Product Change Notification

1. ECR #: 164007
Notification #: 330

3. Series:
• SSM - .025 SOCKET STRIPS

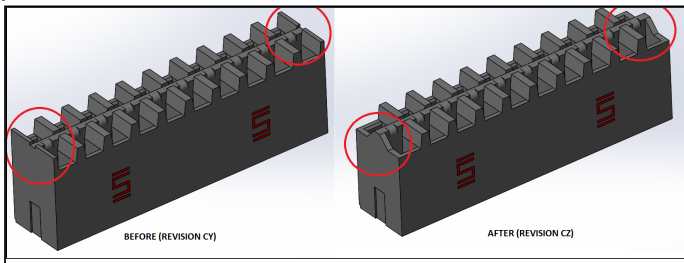
5. Description of Change:
Reduction in size of end-walls of the plastic insulator housing. This will be a rolling change (inventory at current revision will be exhausted prior to implementation).

6. Method of Identifying Change
This change is visible with the unaided eye. New SSM-1XX-XXX-DH-XX-XX-XX-XX-XX will have reduced plastic volume on the end walls and a new chamfer added.

7. Reason for Change:
This change eliminates non-functional thin plastic that has a history of breaking.

8. Impact of Change on Form, Fit, or Function:
• Form - Form - The change will be visible with the unaided eye. There are no anticipated changes to fit or function.
